**PCN# 20140414001
Design Revision (for Select TMP708/709 Devices)
Change Notification / Sample Request**

PCN Number:	20140414001	PCN Date:	4/14/2014
Title:	Design Revision (for Select TMP708/709 Devices)		
Customer Contact:	PCN Manager	Phone:	+1(214)480-6037
Proposed 1st Ship Date:	10/14/2014	Estimated Sample Availability:	Date provided at sample request
Change Type:			
<input checked="" type="checkbox"/> Design

Sample product shipping label to indicate die rev location (**not actual product label**)

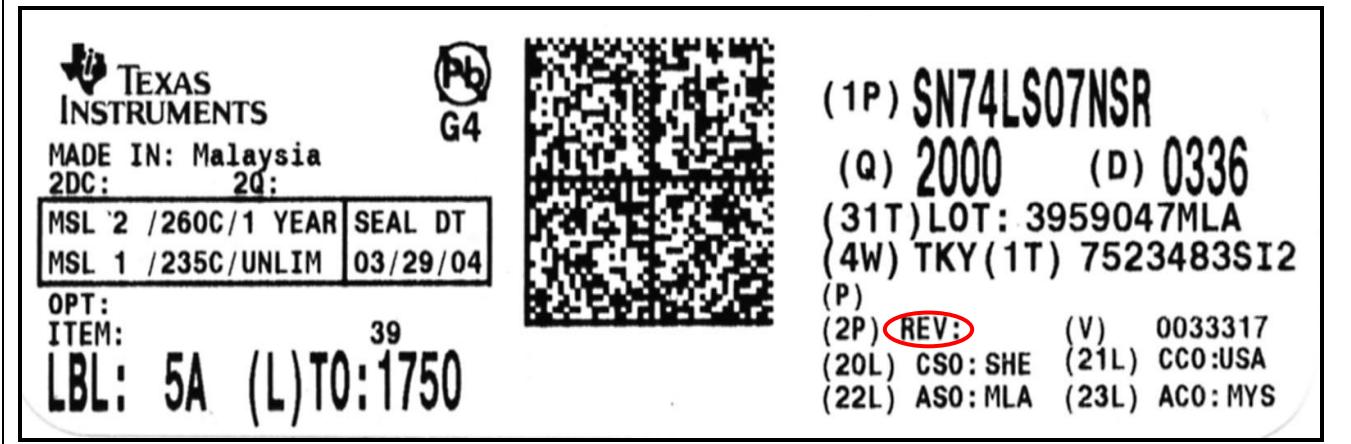
Die Rev designator will change as shown in table & sample label below:

Current	New
Die Rev [2P]	Die Rev [2P]
A	B
